P22-19
Hotel Redevelopment
REVISED

Property Owner: Legacy Hotel of Medina LLC
Applicant: Jim Gerspacher
Location: 253 and 257 South Court Street
Zoning: C-2 (Central Business)
Request: Revised Conditional Zoning Certificate and Site Plan approval for the construction of a hotel

Z22-24 Previously Approved Plan - For Reference

SHEET NAME
SITE PLAN AND BUILDING FOOTPRINT

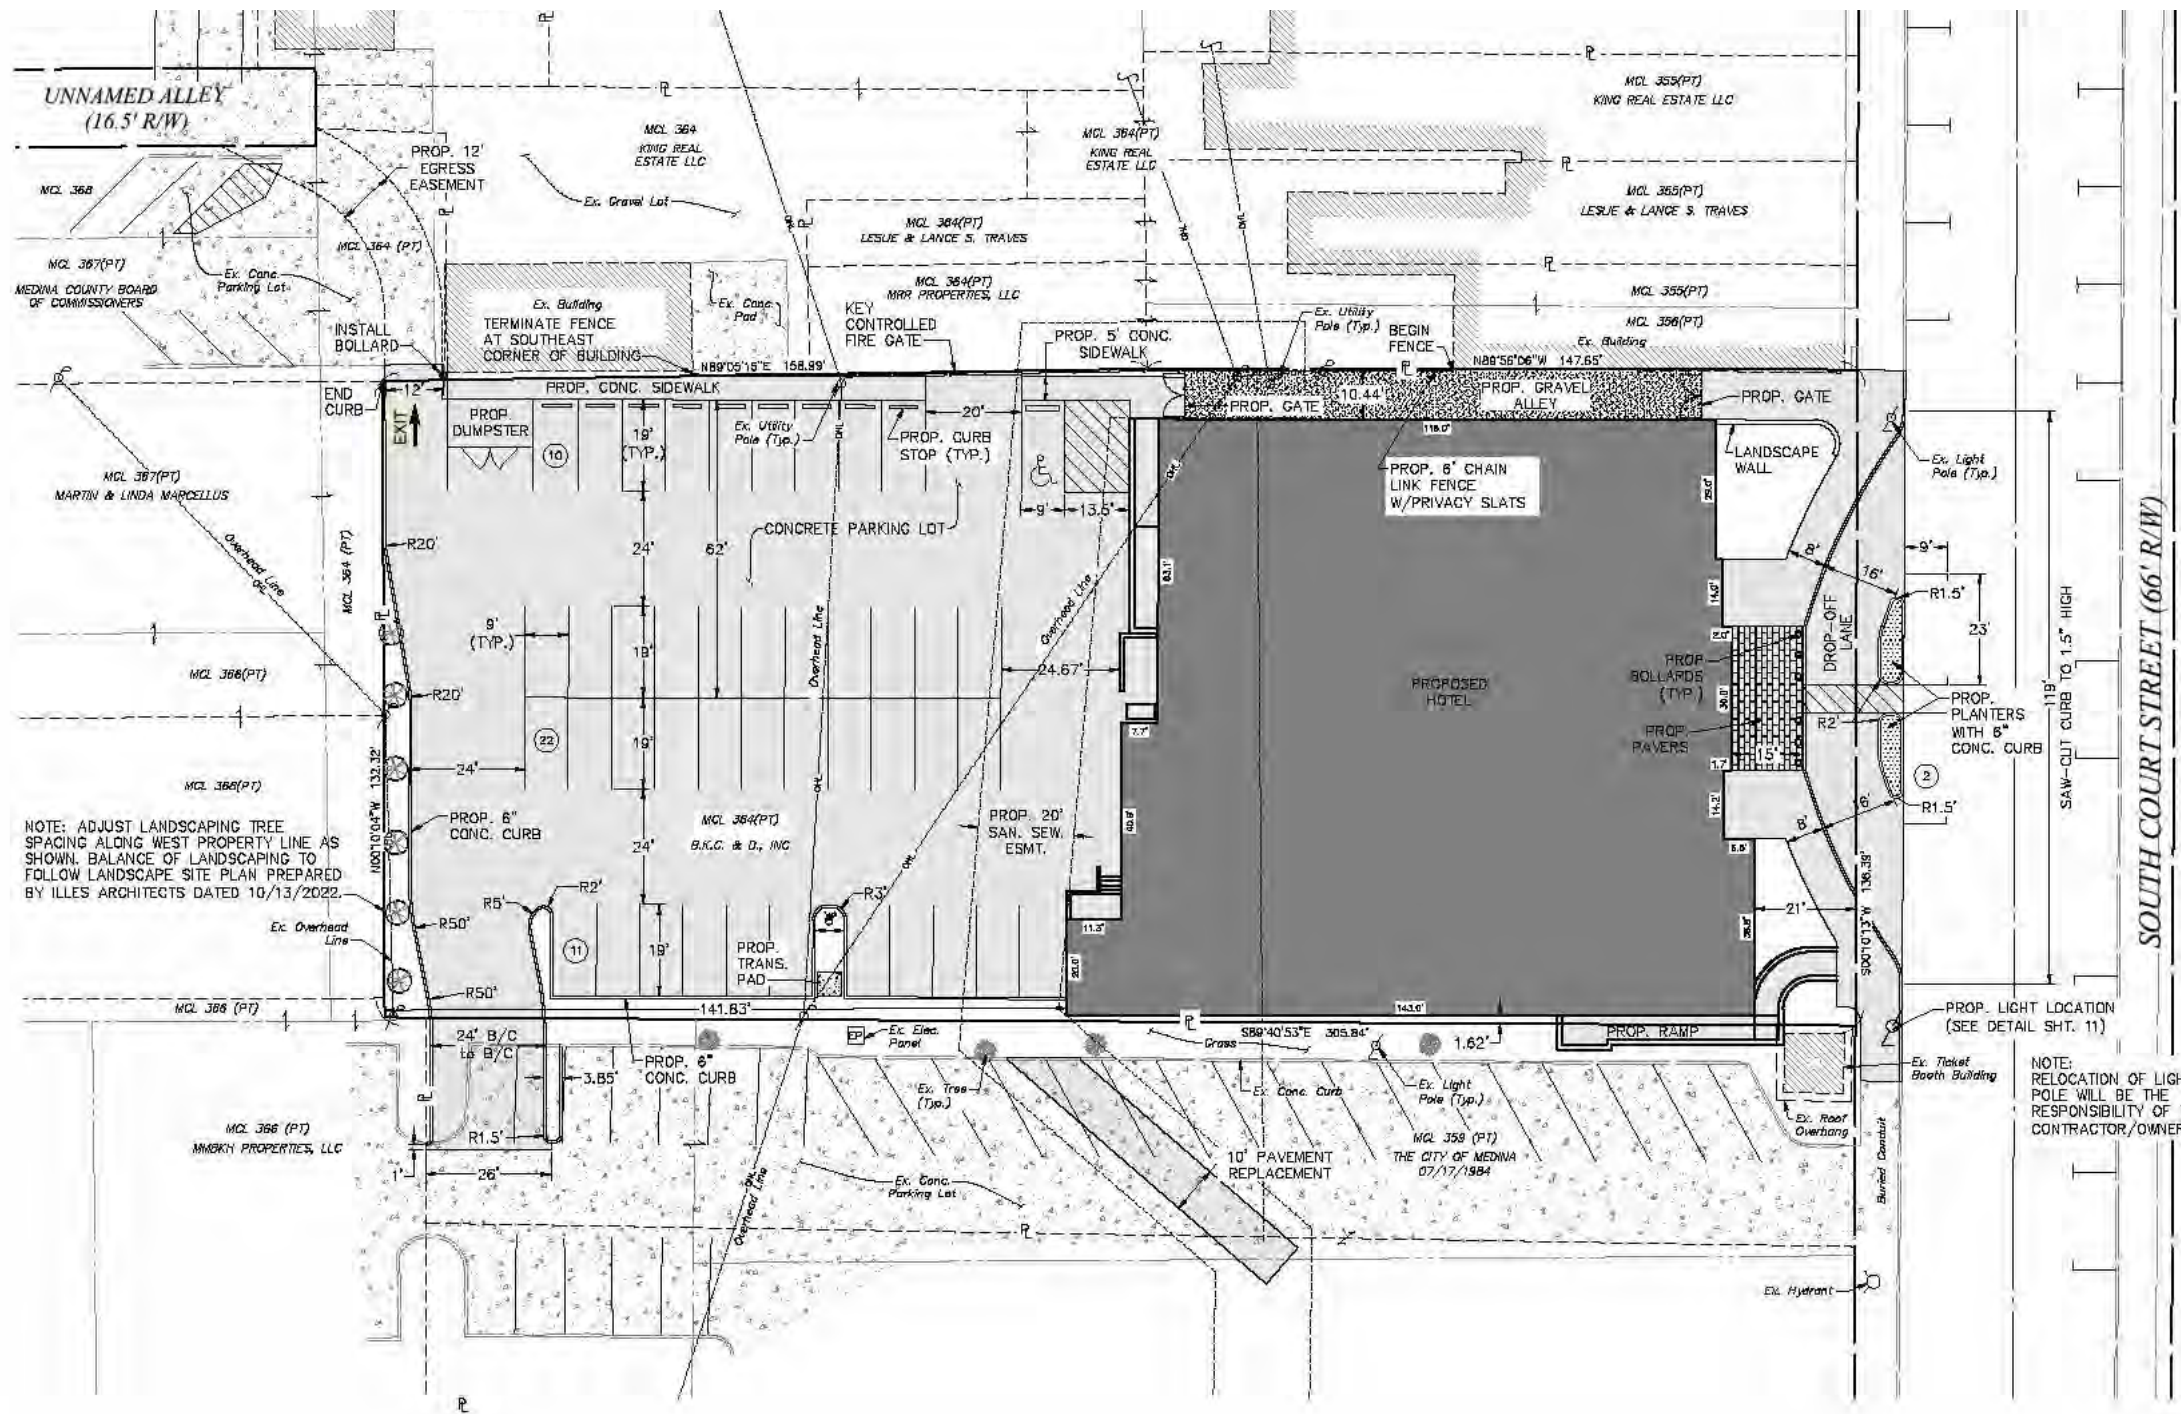
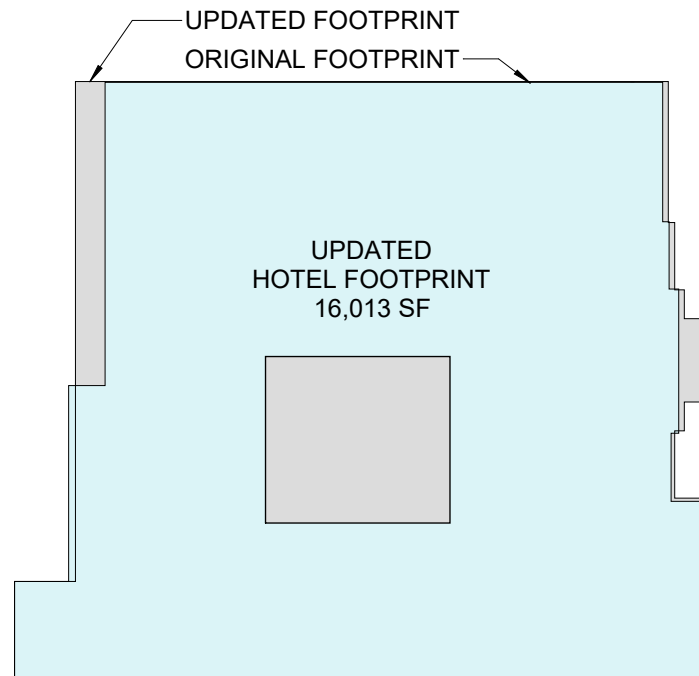
Maximum Building Footprint – The previously approved building contained an open courtyard in the center of the entire building. The proposed building’s footprint has increased due to the removal of the courtyard on the first floor and modifications to the east and west sides of the building. The open courtyard remains on all other floors of the building and the width of the building adjacent to South Court Street remains unchanged. The applicant has provided a detail of the changes in the building footprint on the “Site Plan and Building Footprint Original” page.

- 1- Footprint increase of 3,229 sf: Previously approved footprint was approximately 12,784 sf and proposed is 16,013 sf.

While there are minor changes to the perimeter dimensions, the square footage increase is largely due to the infill of the courtyard on the first floor. The courtyard remains a feature in the project accessed by guests on the second floor. The exterior perimeter of the hotel has grown negligibly, and it would be nearly impossible for someone to see that increase from outside the hotel. Please see below a snippet showing both footprints overlapped (blue is original footprint – gray is updated)

SHEET NAME
HOTEL - WEST EXTERIOR
ELEVATION

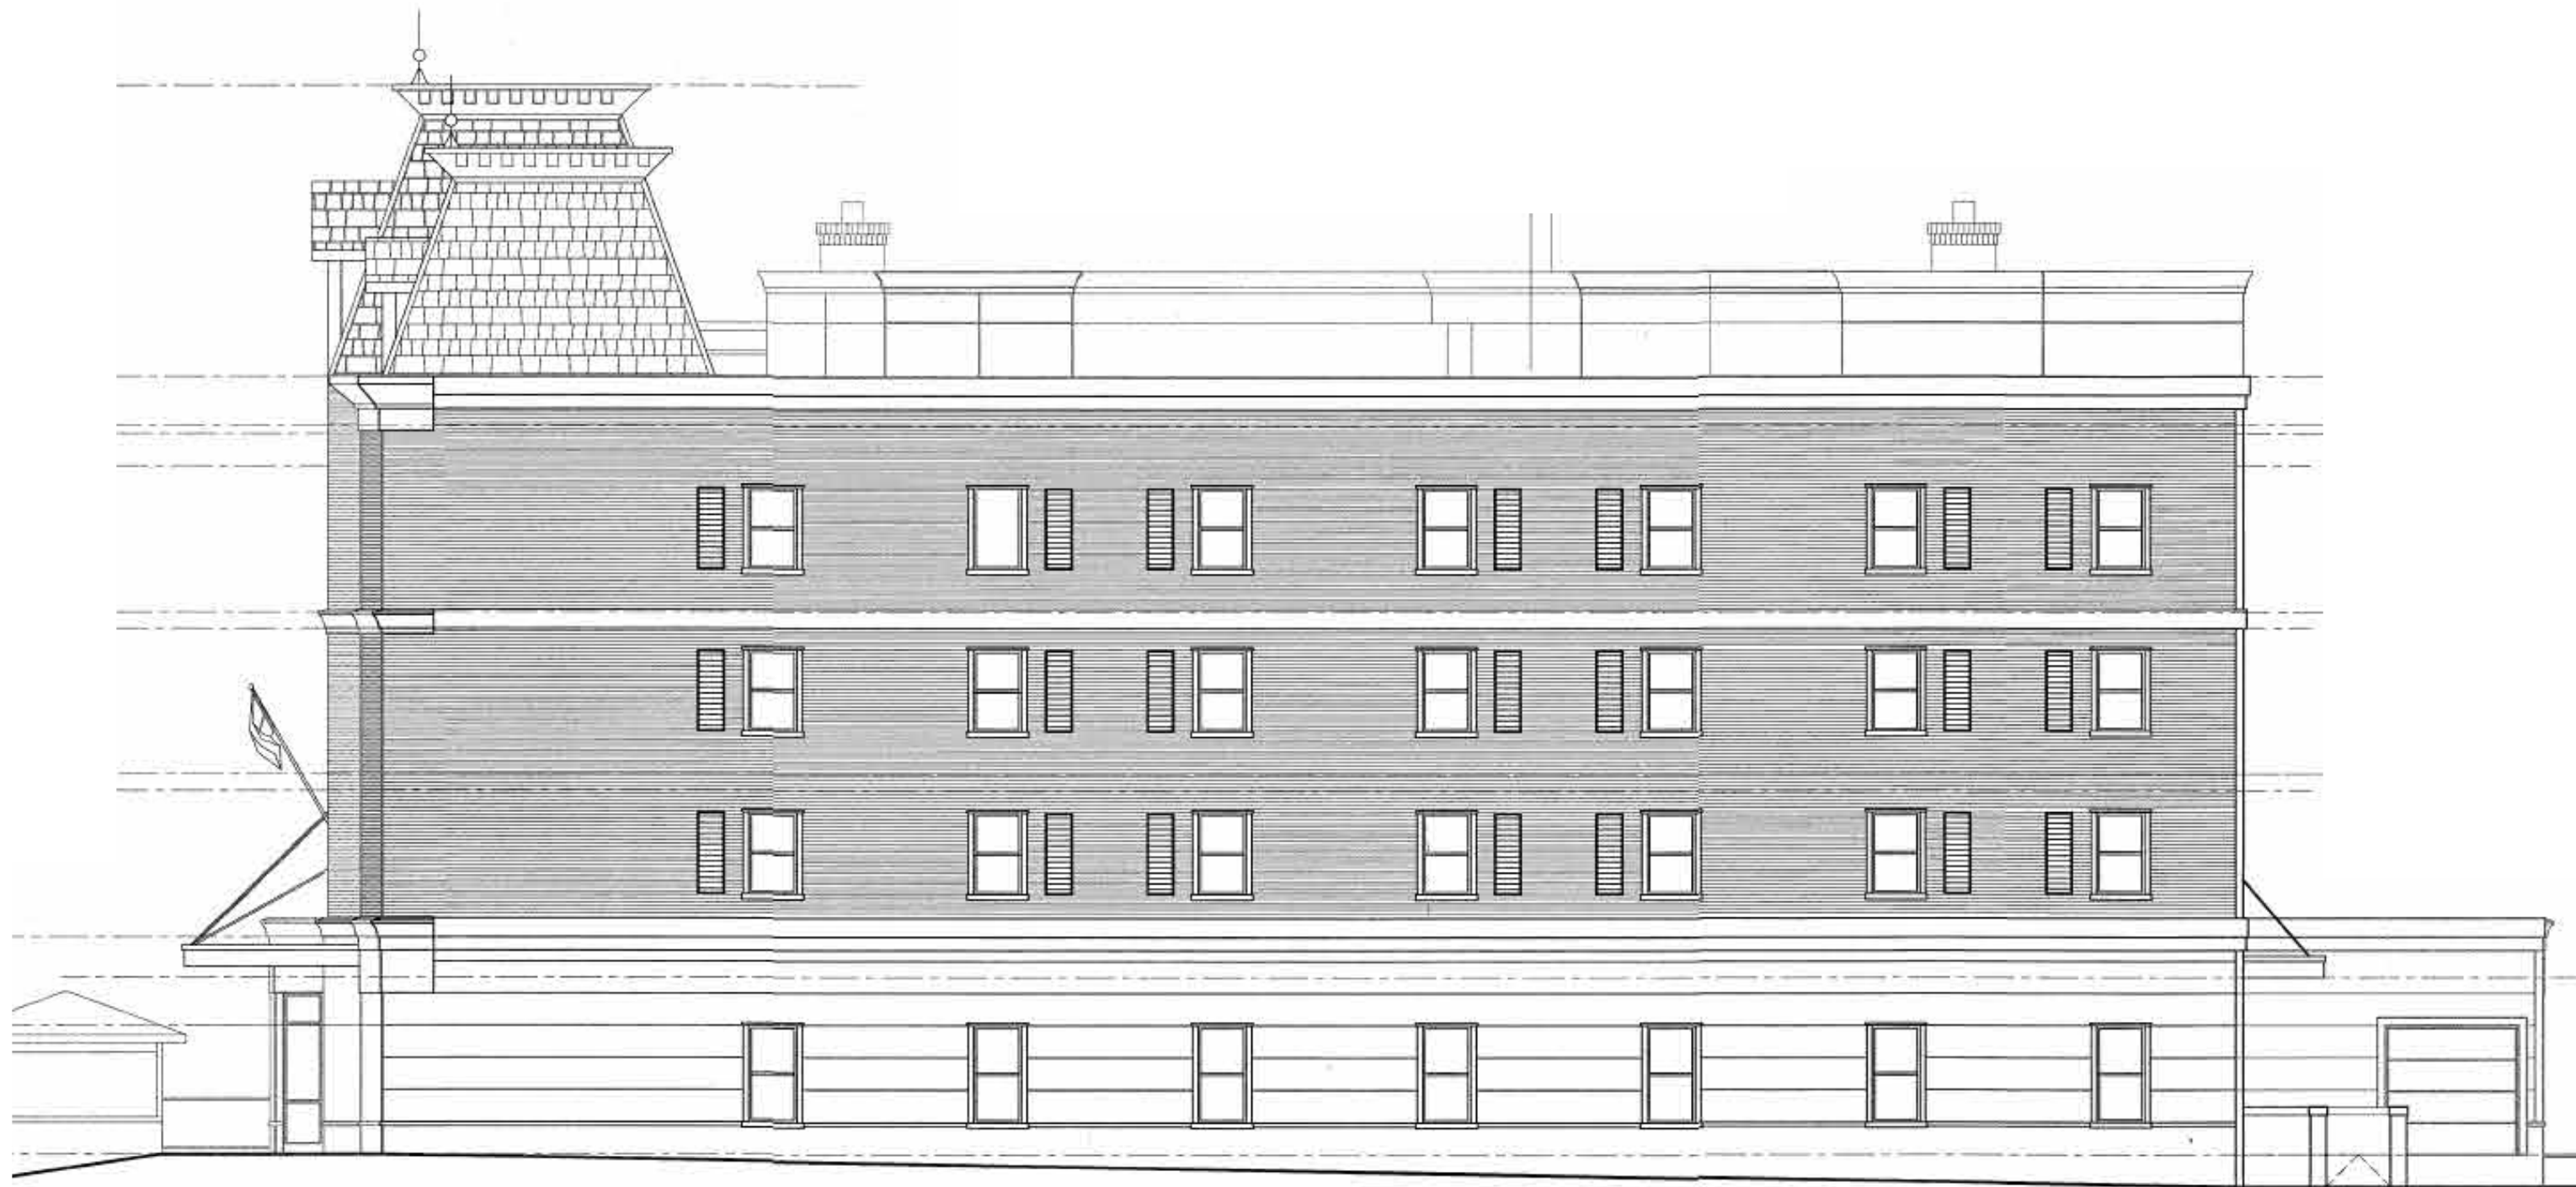
The rear elevation has been revised to remove a first floor ramp and doors. Doors have been added to the side elevation on the first floor.

SHEET NAME: ROOF OUTLINE & HEIGHT
 SHEET NO.: HSK05

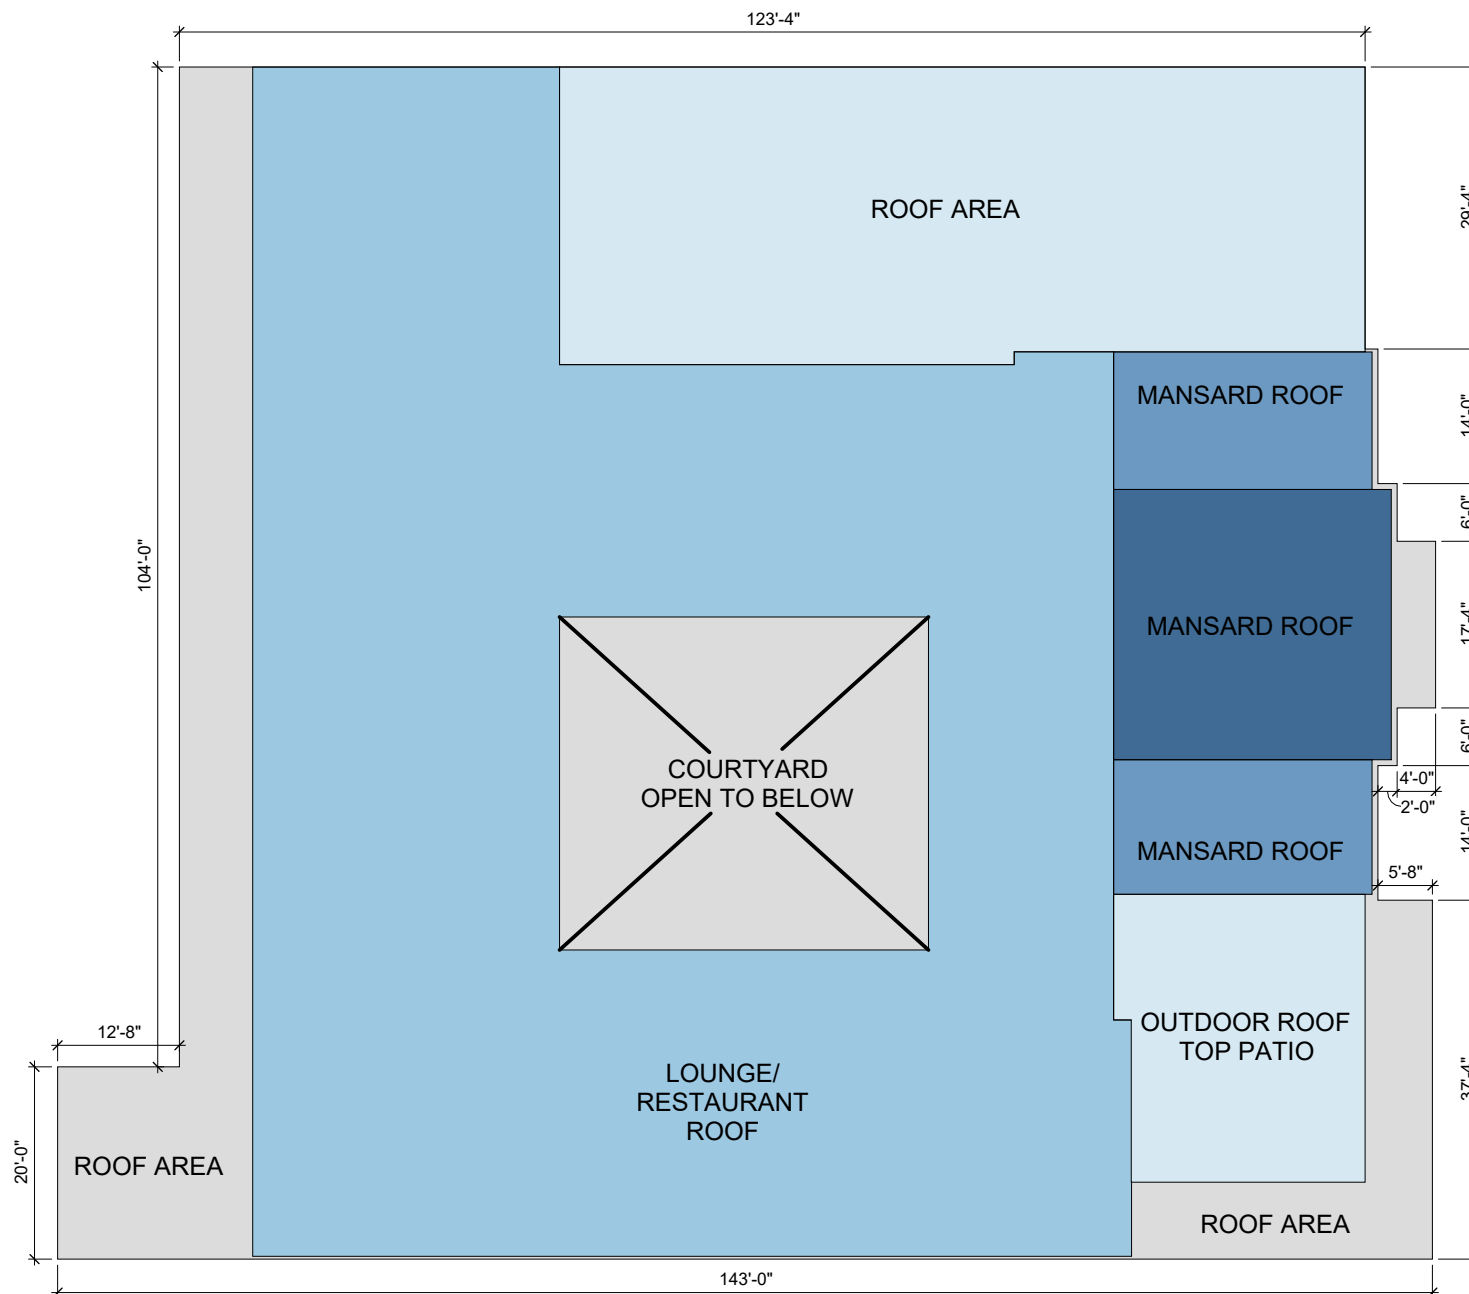
Building Height – The effective building height of 55 ft. was previously approved by the Planning Commission, which can approve a building height up to 60 ft. The overall effective height of the building has increased by 6 ft. to sufficiently accommodate mechanical components. The effective height of the revised building is 61 ft., which is the roof line of the building. Decorative architectural features that do not have functional interior area above this height are not included in the effective height of the building.

- 2- Height increase: the original approved elevations show the top of roof at 55'-0", the updated drawings show 61'-0". The additional height requested is 6'-0" higher than the previously approved plans. This increase in floor height accommodates more advanced HVAC systems than previously approved without sacrificing quality of interior spaces. Unlike the previous design, no suites will have exterior louvered grilles on the newly proposed plans. Without the new height variance, the available methods of construction are narrowed to options that are not as feasible and accommodating mechanical duct work becomes difficult.

The mansard roof was previously approved at 66'-8", the proposed is at 71'-0". This is purely an architectural feature that gives the hotel its historical character and is visible on S Court Street from all sides. The added height is not being used to generate profit to the developer(s).
